IBERDROLA RENEWABLES

Re: Comments of Iberdrola Renewables, Inc. regarding the Tule Wind Project Draft DEIR/DEIS– Modified Project Layout

Re: Comments of Iberdrola Renewables, Inc. on the Joint Draft Environmental Impact Report - Draft Environmental Impact Statement (DEIR/DEIS) for the East County Substation/Tule Wind/Energia Sierra Juarez Gen-Tie Projects

Figure 1 - Modified Project Layout

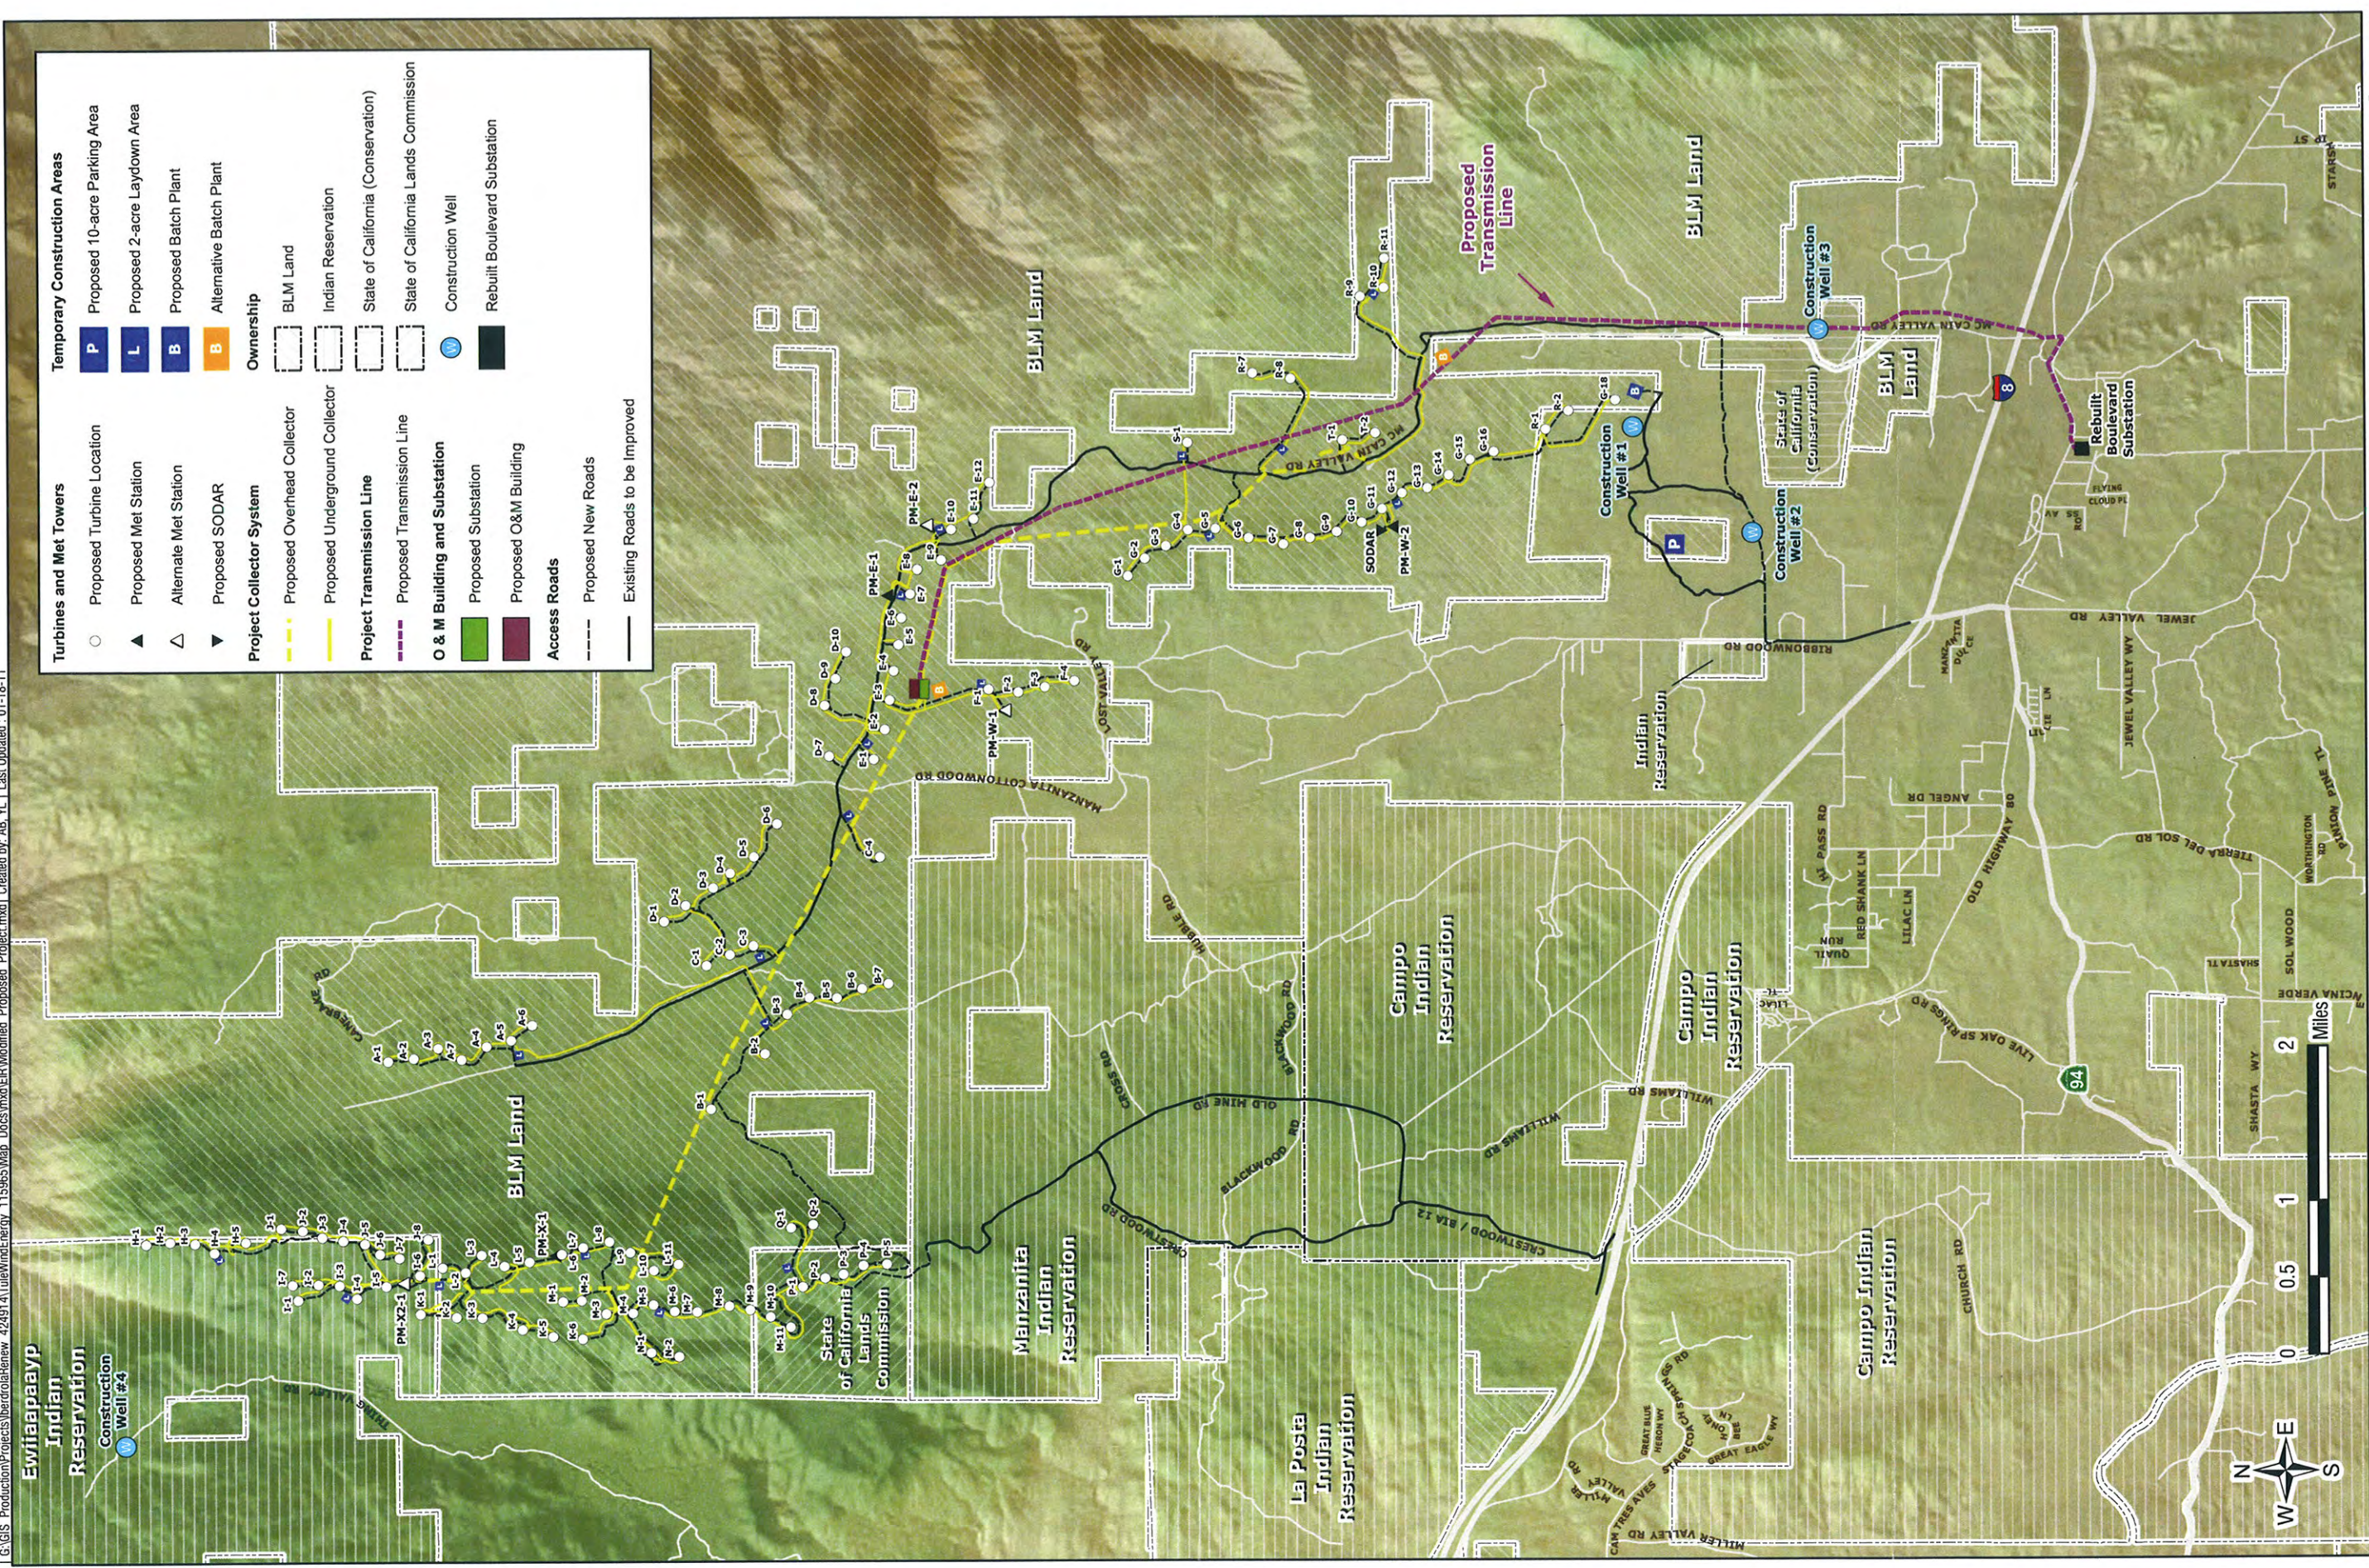
IRI is proposing minor modifications to portions of the Tule Wind Project facilities. Attachment A includes Figures 1 and 2 that graphically depict the modified project layout and the limited differences between the project layout analyzed in the Draft EIR/EIS and the modified project layout, respectively. The changes to the proposed project make minor adjustments to avoid resources and reduce the project's overall environmental impacts. Table A, *Key Project Components by Jurisdiction*, identifies the project modifications related to primary project features (turbines, transmission line, and access roads). Table B, *Project Components*, identifies a comparison of the change in impacts between all project

components. For example, the modified project layout proposes a maximum of 128 turbines, which is six (6) fewer turbines than were analyzed in the Draft EIR/EIS, and a resultant decrease of approximately 17 acres in permanent impacts. In addition, the modified project layout proposes a substantial reduction in the number of new access roads and improvements to existing roads compared to the project layout analyzed in the Draft EIR/EIS. As noted in Table B, the modified project layout reduces the number of improved new access roads from 114 to 75, and existing roads from 23 to 15 as opposed to 114 new roads and improvements to 23. This a reduction of 3.4 miles and 12.4 acres of permanent impacts as compared to the project layout analyzed in the Draft EIR/EIS. Other summary and project comparison (Draft EIR/EIS project layout vs. modified project layout) information attached includes: Table C – *Jurisdictional Areas*; and Table D – *Vegetation Communities*.

IRI conducted additional biological and cultural resources surveys on land where project modifications are located wherever they fell outside of areas previously studied. Figure 2 identifies the additional land area surveyed for cultural and biological resources. For each of the environmental issue area sections identified in the Draft EIR/EIS, analysis by our consultant HDR (as documented in the revised Draft EIR/EIS environmental issue areas sections) has determined that the modified project layout will result in similar or reduced impacts as compared to the project layout analyzed in the Draft EIR/EIS. Further, no new significant impacts justifying recirculation of the Draft EIR/EIS have been identified.
